From: drainage <drainage@midsussex.gov.uk>
Sent: 27 November 2025 09:42:01 UTC+00:00
To: "Peter Davies" <Peter.Davies@midsussex.gov.uk>
Cc: "drainage" <drainage@midsussex.gov.uk>
Subject: 2025.11.27 Re: DM/25/2880 - 13 Beaconsfield Close Burgess Hill West Sussex
RH15 9AT

We understand the proposed application is for the retention of existing warehouse and creation within it of 3 new dwellings.

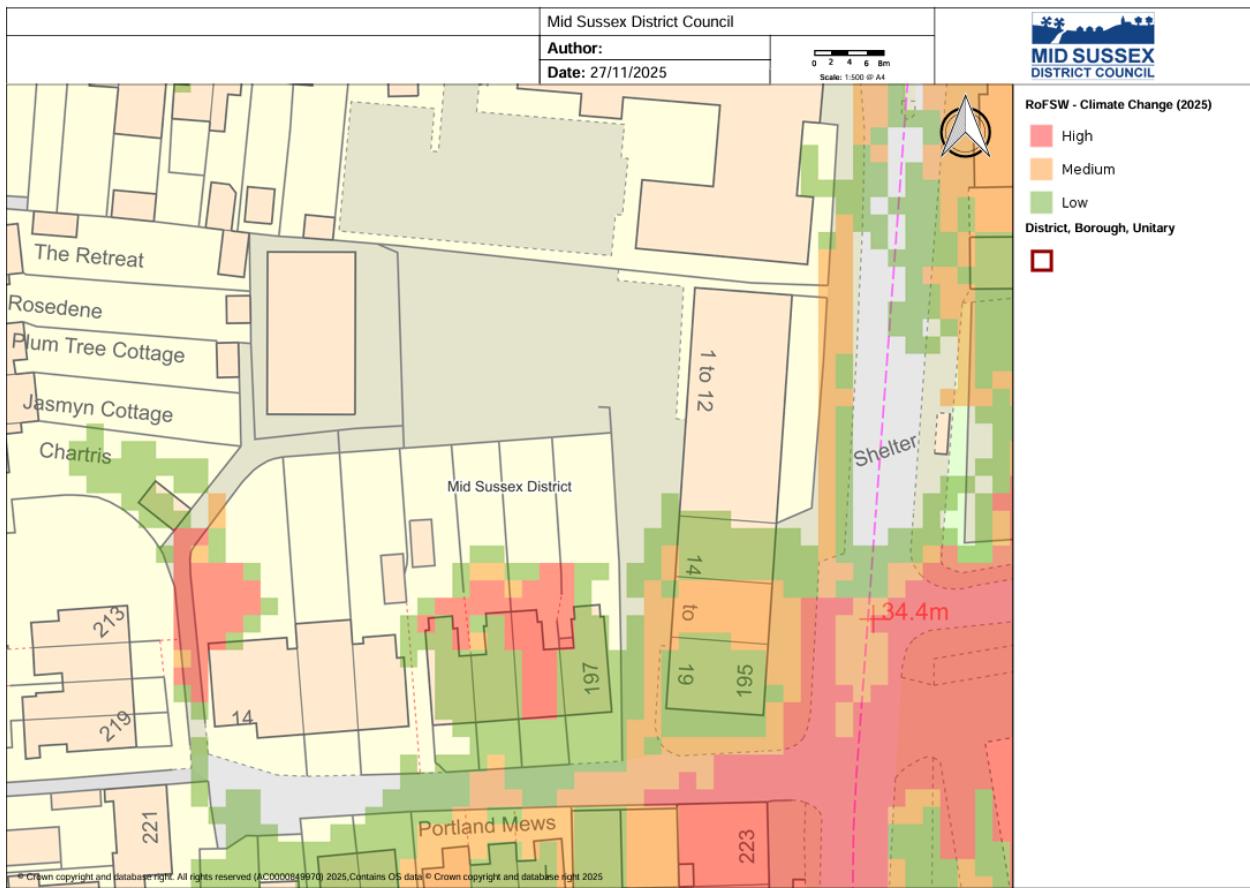
The Risk of Flooding from Surface Water mapping suggests the site is shown to be at very low surface water flood risk (comparable to flood zone 1) for the present day (2025) and within the climate change range of 2040 – 2060.

As the proposed development would result in an increase in site vulnerability, any potential escape route from the site is shown to be at High Risk of surface water flooding (equivalent to Flood Zones 3a and 3b) under present-day (2025) and within the projected climate change scenario for 2040–2060

The applicant must therefore demonstrate, at this stage of planning and as part of the Flood Risk Assessment, that safe access and egress can be achieved for the lifetime of the development (taken as 100 years for residential use, in line with NPPF guidance). The plans should evidence:

- A safe route of access and escape that is set above the estimated design flood level and provides a continuous connection to an area outside of identified flood risk.
